The School District of Greenville County

Addendum No. 1

Re: Sevier Middle School – Building Envelope Repairs

IFB No.: **323-20-5-4**

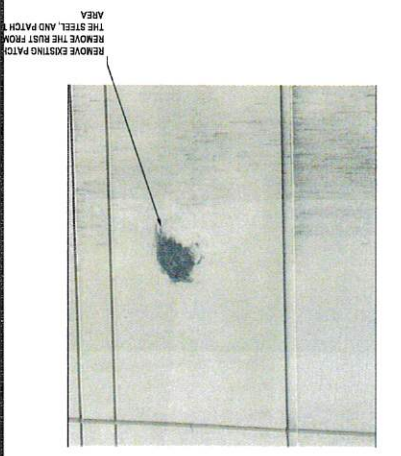
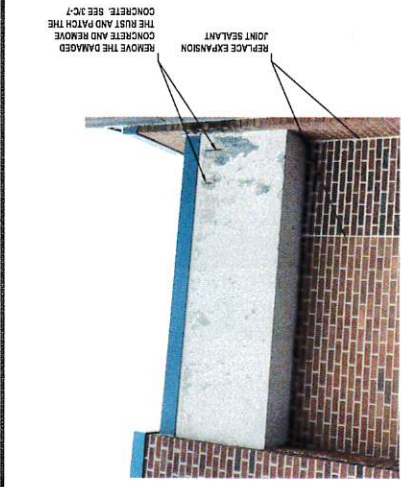
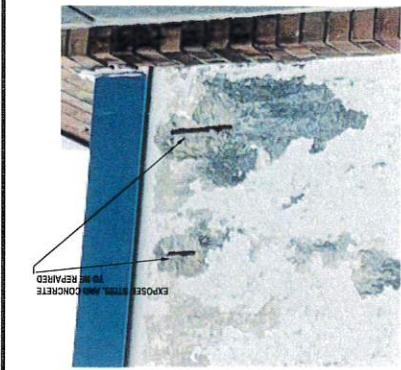
1. The storage building in the back of the complex shall become part of the project. The contractor shall remove the existing caulking and backing rod on the exterior face of the building. Then install new backing rod and caulk. The grill and door frame has never been caulked; the contractor shall install silicone caulk around the frames. Attached is a drawing C-7 illustrating the scope of the work.
2. The curtain wall system at the main entrance shall also become part of the scope of the project. The contractor shall replace the caulk and wet seal the windows.
3. Where the curtain wall abuts the concrete sidewalk, the joint between the two -remove the existing caulk and re-caulk the joint.
4. Do not caulk the edge of the threshold at the doors.
5. Change the completion date of the project to October 2, 2023. Any punch list items shall be completed by October 9, 2023.

1 CONCRETE PATCH REPAIR - PRECAST SECTION
 C-7 SCALE: NONE

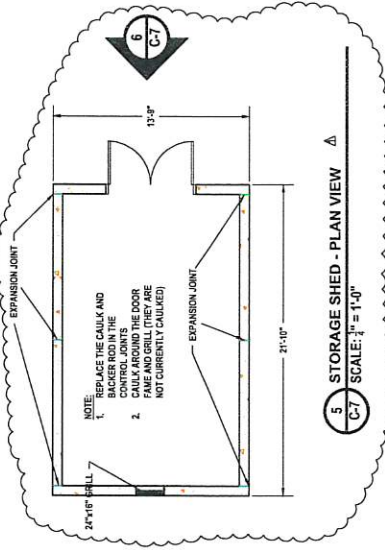
- THE INSIDE TOP CORNER OF THE PRECAST CONCRETE, THE
 REPAIR SHALL BE REINFORCED AND WILL BE REPAIRED AS
 PART OF THE PROJECT.
 - THE CONTRACTOR SHALL REMOVE THE LOOSE CONCRETE,
 RUST FROM THE STEEL. THE CONCRETE SHALL BE CHIPPED
 OUT TO SOLID CONCRETE. MIN. OF 3" AROUND THE STEEL.
 THE STEEL SHALL BE PAINTED WITH SHERMAN WILLIAMS
 FASTLINE PRIMER SURFACE AND SEALER OR EQUAL.
 THE INLETS AND CONCRETE SHALL BE PATCHED WITH
 RANKCRETE OR EQUAL. RANKCRETE SHALL BE MIXED,
 APPLIED AND CURED ACCORDING TO THE
 MANUFACTURER'S INSTRUCTIONS.

- THE FINAL REPAIR SHALL BE FLUSH WITH THE EXISTING
 CONCRETE.
 - THE CONCRETE PATCH SHALL BE REINFORCED AND
 CURED ACCORDING TO THE MANUFACTURER'S INSTRUCTIONS.

- THE CONTRACTOR SHALL REMOVE ANY RUST ON THE
 STEEL AND PAINTED WITH SHERMAN WILLIAMS FASTLINE
 PRIMER SURFACE AND SEALER OR EQUAL.
 - CONCRETE SHALL BE PATCHED WITH RANKCRETE OR EQUAL.
 RANKCRETE SHALL BE MIXED, APPLIED AND CURED
 ACCORDING TO THE MANUFACTURER'S INSTRUCTIONS.

- THE FINAL REPAIR SHALL BE FLUSH WITH THE EXISTING
 CONCRETE.
- THE CONTRACTOR SHALL CLEAN ANY OVERLAP AND THE
 GROUNDS OF ANY DEBRIS FROM THE OPERATIONS.
